SOUTH WEBER CITY PLANNING COMMISSION AGENDA

RIVERSIDE RV PARK REVIEW

**RE: RIVERSIDE RV PARK – Conditional Use and Site Plan
Review Memo**

RIVERSIDE R.V. PARK

EXISTING SITE CONDITIONS
RIVERSIDE R.V. PARK
851 COTTONWOOD DRIVE
SOUTH WEBER, DAVIS COUNTY, UTAH

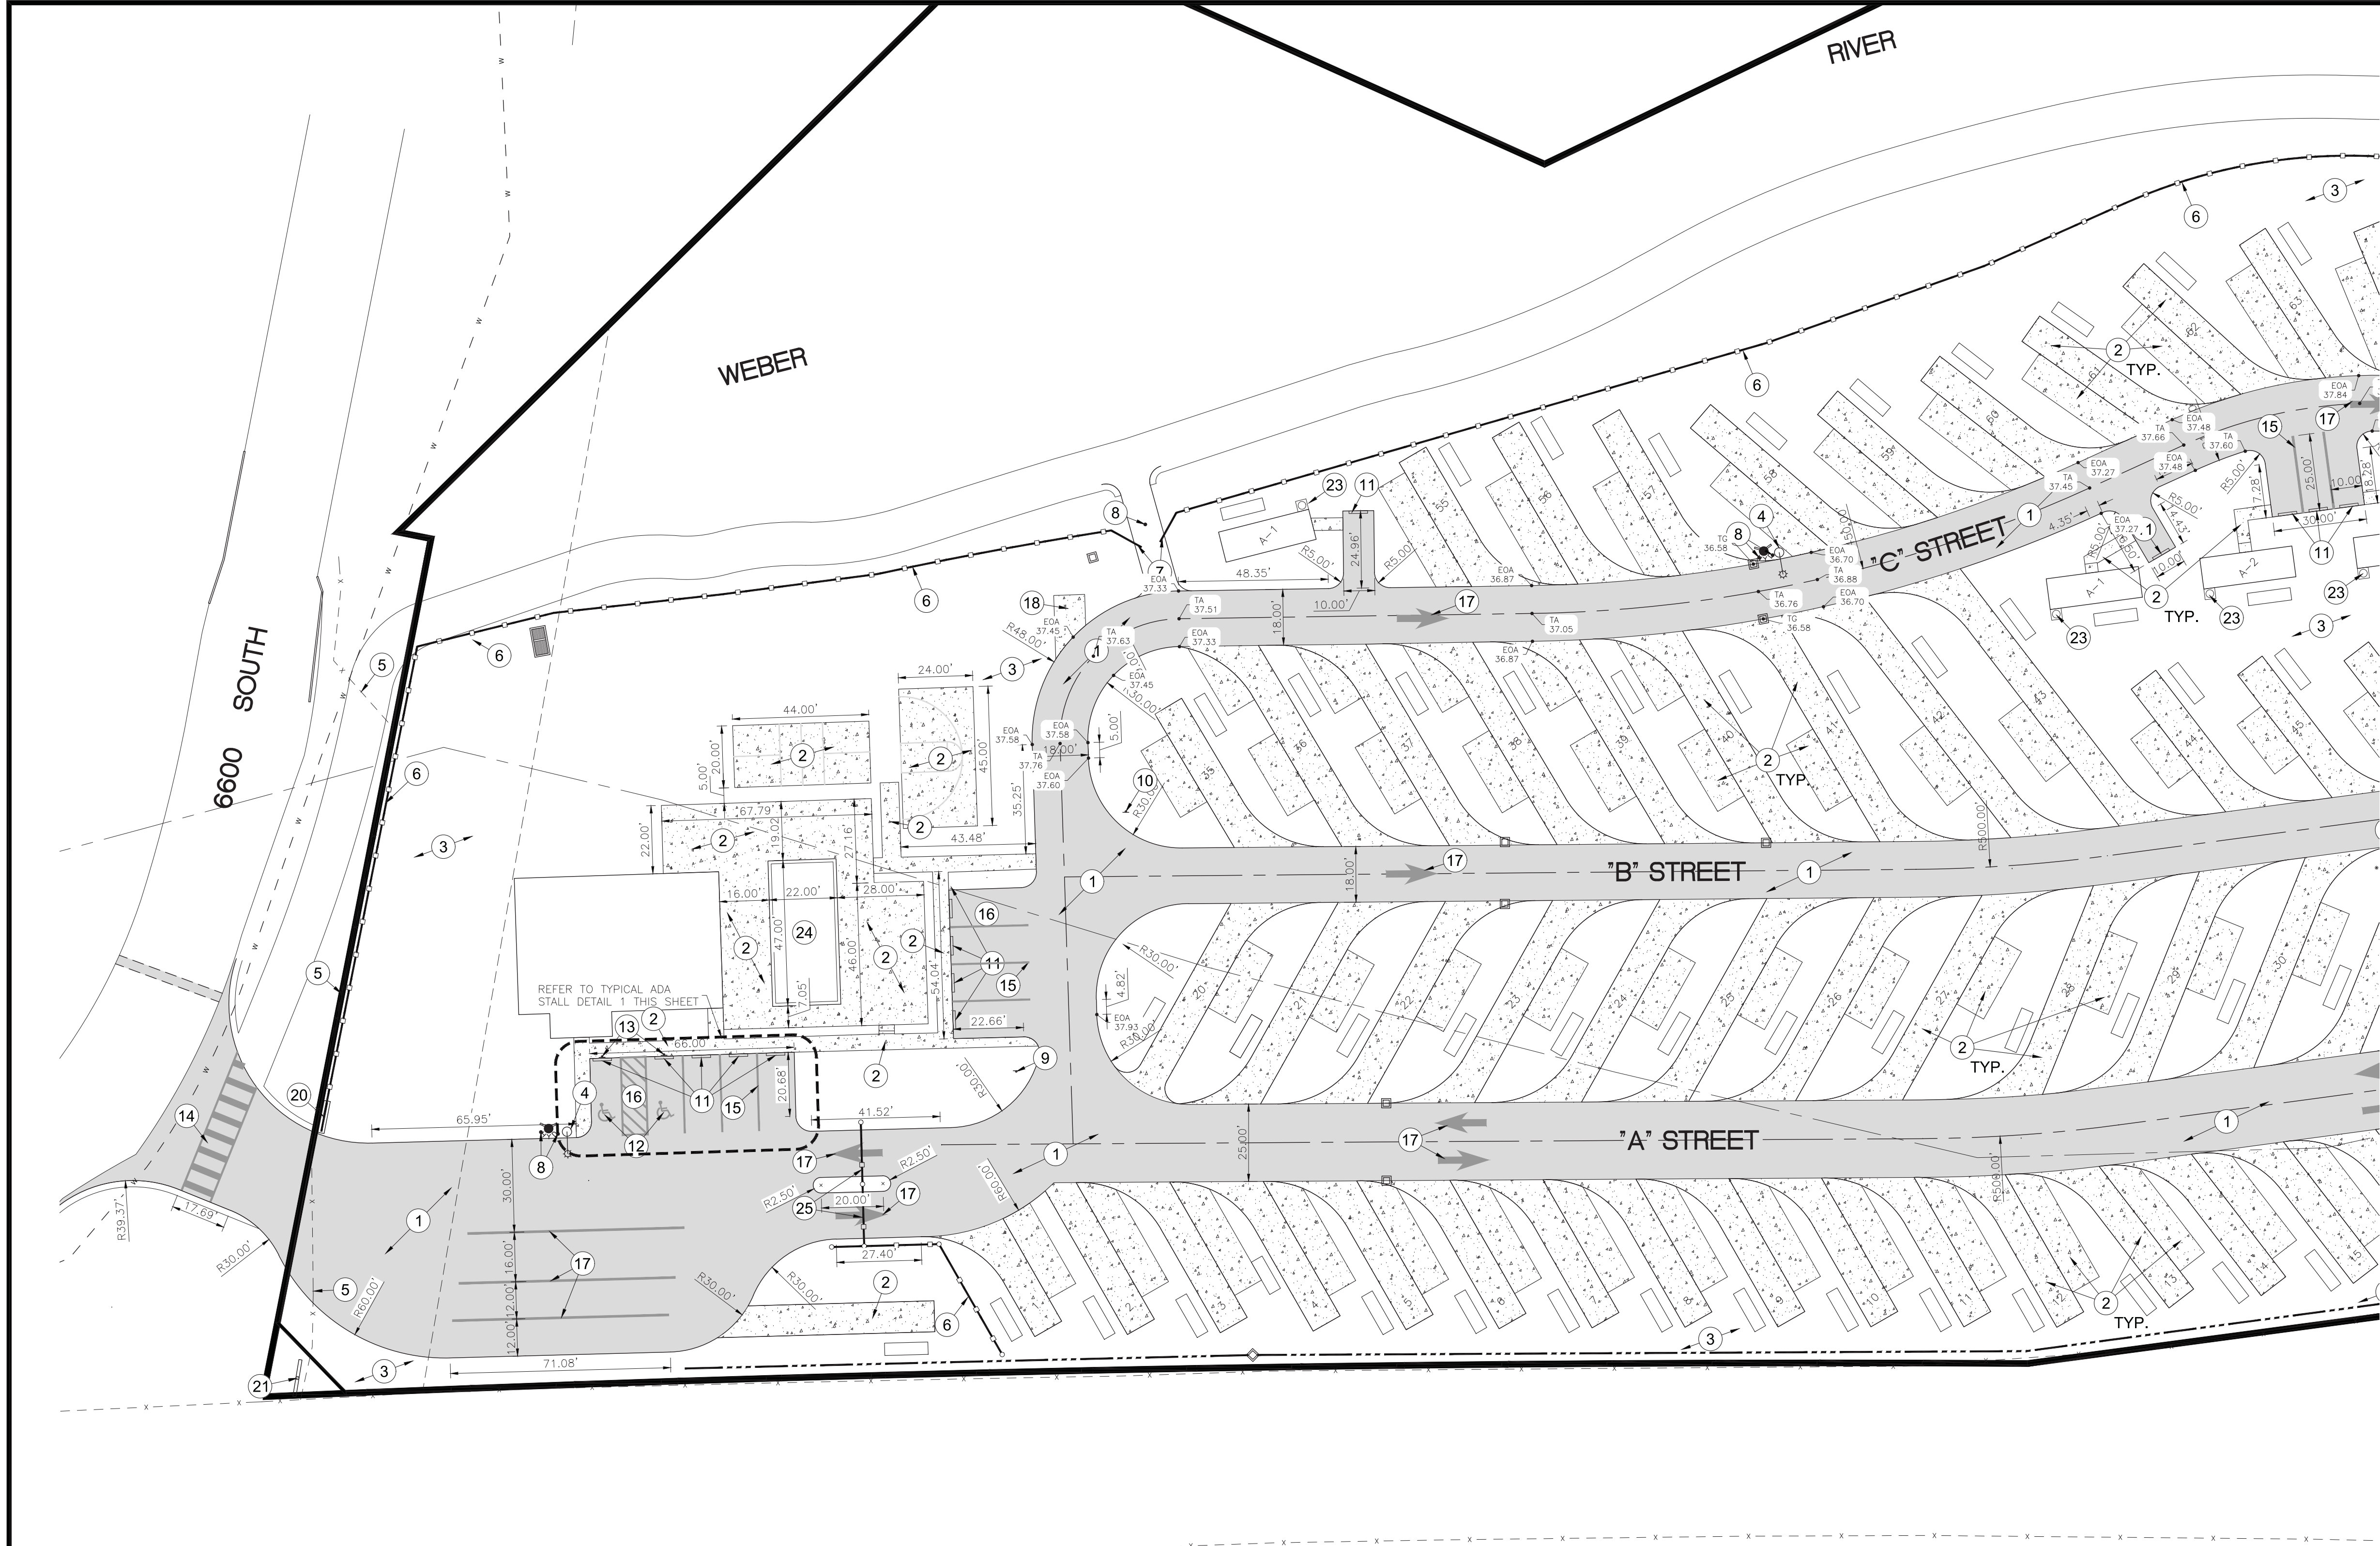
ORDINANCE COMPLIANCE: There are several conditions listed in Section 10.7F.1 of the Zoning Ordinance that I believe have all been met. The only site requirement of 10.7F.2 that has not been met is the requirement for a 100' setback for any sites to a road. The sites are considerably less than 100' from the freeway, but there is a provision in the code that allows the Planning Commission to approve something less. In this case, I don't think the freeway will be impacted in any way and there is a large approx. 70' space from the freeway right-of-way fence to the actual closest travel lane. I believe the Planning Commission has reasonable justification to approve a less than 100' setback on the I-84 side.

OTHER: The main waterline within the site will need to be City owned and maintained and will therefore require an easement be granted to the City for that purpose. Other utilities within the site will be private.

STAFF RECOMMENDATION: I recommend the Planning Commission approve this conditional use/site plan with the reduced setback along the freeway frontage.
